**GOVERNMENT OF THE DISTRICT OF COLUMBIA
DEPARTMENT OF TRANSPORTATION**

MEMORANDUM

SUBJECT: ZC Case No. 05-38B – View at Waterfront

Figure 1 Site Design and Access (Source: Gorove/Slade)

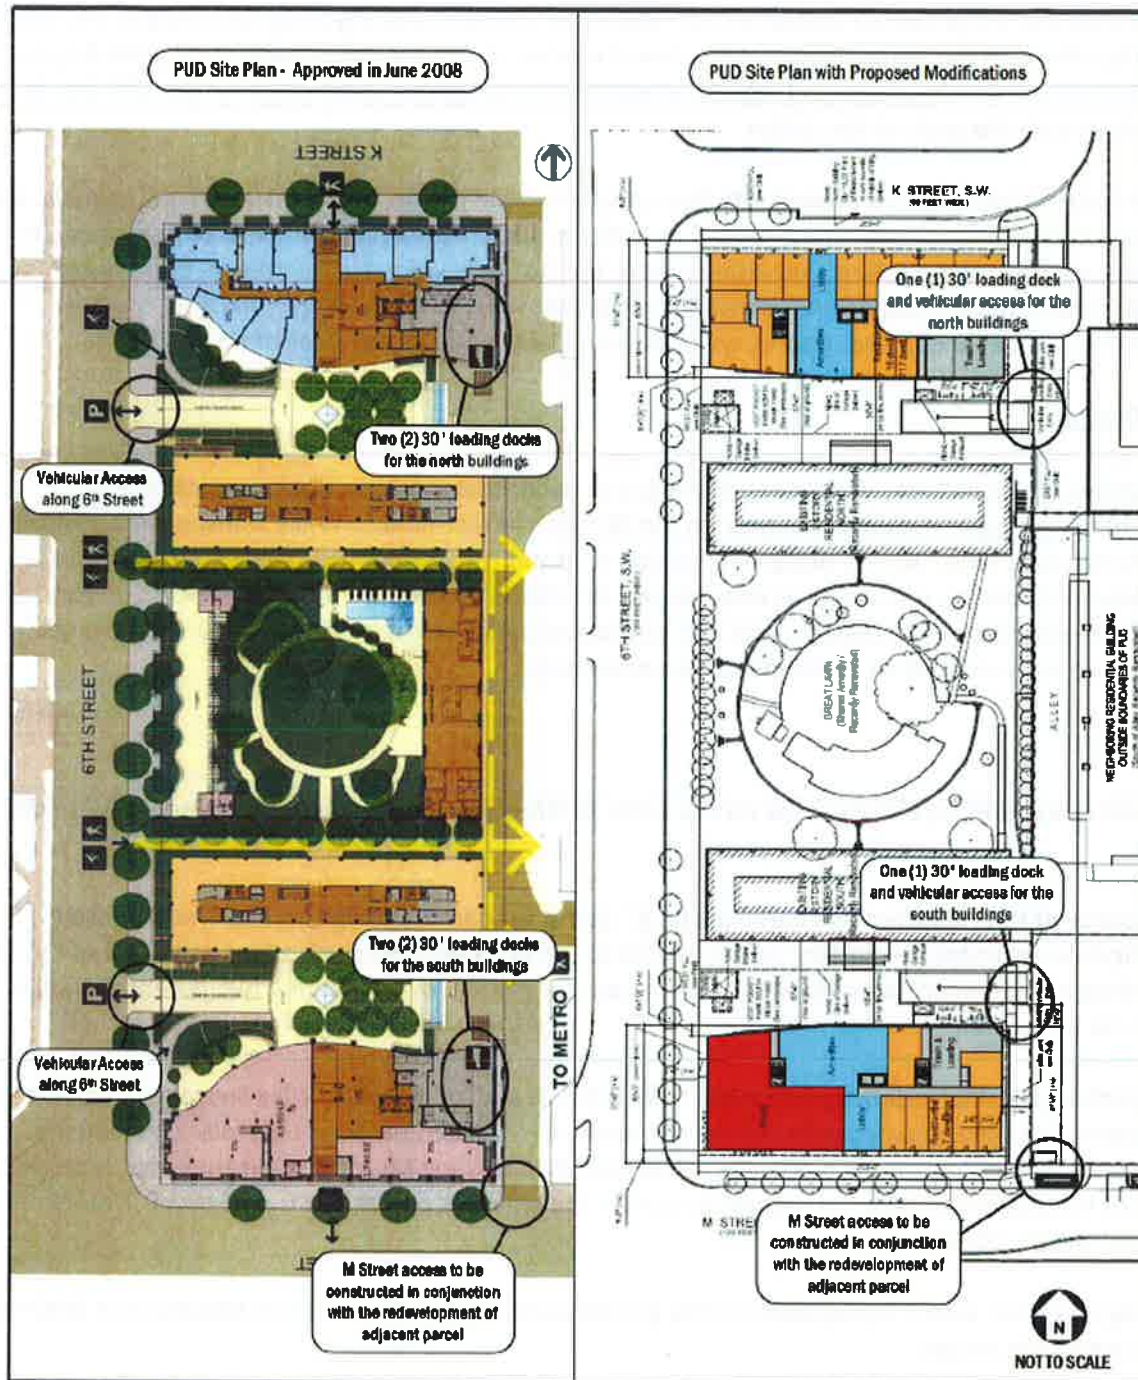
The approved PUD featured two curb cuts on 6th Street for parking garage access. The proposed modification relocates the parking garage access to the private north-south alley to the east of the site. This change greatly improves the vehicle site access for the site by eliminating two potential conflict points on 6th Street.

Loading and trash access is proposed via the private north-south alley, and is in keeping with DDOT's approach to site access.

As designed, the retail space in the South Building does not have interior access to the loading berth. The Applicant proposes to handle loading for the retail component on the curbside. All loading and trash activities should be accommodated on-site in order to minimize the impact of loading on the District's transportation network. The retail space does not meet the requirements for a curbside commercial loading zone and a loading zone will not be approved by DDOT. The building should be altered to provide interior access between the loading facilities and the retail space.

Of note, the site currently features a large privacy wall on 6th Street that is likely in public space. This wall, if in public space, does not meet public space standards and should be brought into compliance as part of the subject development. DDOT also expects utility vaults, which are not shown on the site plan, be accommodated on private property. Final design of the public space will be determined during DDOT's public space permitting process.

- Redesign the South Building such that all loading needs be accommodated onsite;
- Provide at least 8 short-term bicycle parking stations in the public space; and
- Offer a onetime, one year Capital Bikeshare membership or one year carshare membership to all new residents of the project for the first three years the building is open.
